***AMENDMENTS TO THE DRAWINGS***

*Application No.: 10/758,038*  
*Art Unit 3677*  
*Amendment dated October 3, 2005*

*Attorney Docket No. 0630-1938P*  
*Reply to July 1, 2005 Office Action*  
*Page 8 of 14*

FIG. 1  
CONVENTIONAL ART

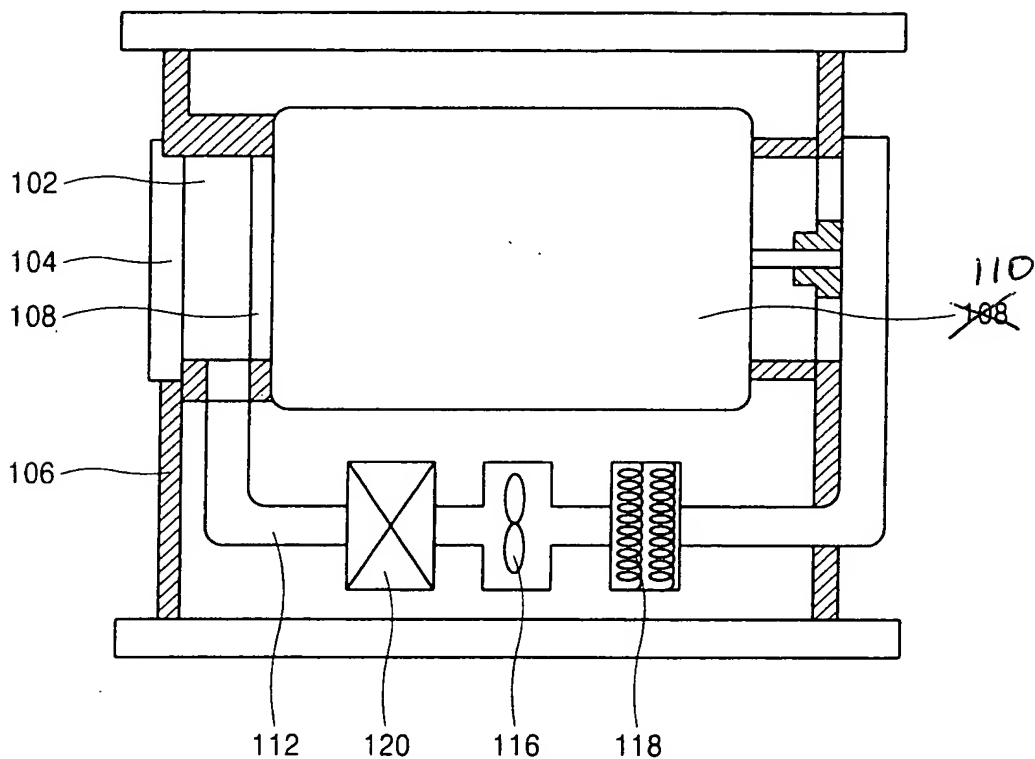
As filed, number 108 refers to two both a drum 108 and an opening portion 108. As amended, Fig. 1 labels the drum as element 110 and retains 108 to label the opening part.

Upon reviewing the drawings, Applicants realized that in Fig. 1, numeral 108 is used to label two separate elements of that figure. Accordingly, Applicants submit concurrently herewith Proposed Drawing Corrections for the Examiner's approval, which addresses this error. Accordingly, consideration and approval of these proposed drawing corrections are respectfully requested.
